STATE OF CONNECTICUT
CONNECTICUT SITING COUNCIL

Petition of BNE Energy Inc. for a
Declaratory Ruling for the Location,
Construction and Operation of a 3.2 MW
Wind Renewable Generating Project on
New Haven Road in Prospect, Connecticut

Docket/Petition No. 980

Supplemental Pre-filed Testimony of David Pressman

Prospect 1&2's proposed location compared to one another

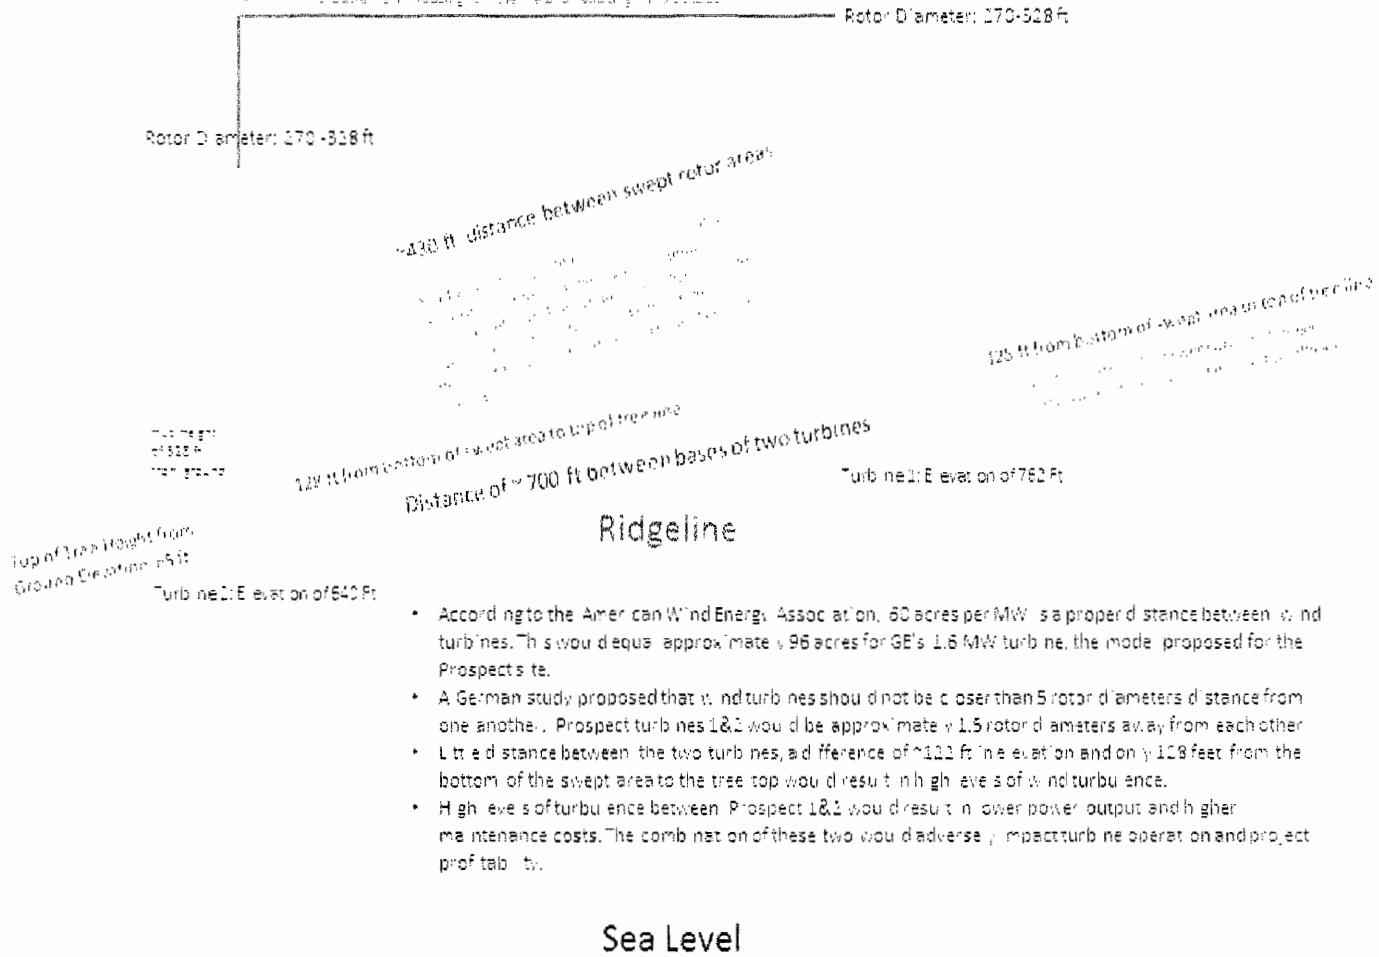
Prospect Turbine 1 is 12 feet higher than Turbine 2, but their swept area is only 1.5 times greater. This difference in height would cause a significant decrease in increasing turbine and reducing wind output.

- According to the American Wind Energy Association, 60 acres per MW is a proper distance between wind turbines. This would equal approximately 96 acres for GE's 1.6 MW turbine, the model proposed for the Prospect site.
- A German study proposed that wind turbines should not be closer than 5 rotor diameters distance from one another. Prospect turbines 1&2 would be approximately 1.5 rotor diameters away from each other.
- Little distance between the two turbines, a difference of ~122 ft in elevation and only 128 feet from the bottom of the swept area to the tree top would result in high levels of wind turbulence.
- High levels of turbulence between Prospect 1&2 would result in lower power output and higher maintenance costs. The combination of these two would adversely impact turbine operation and project profitability.
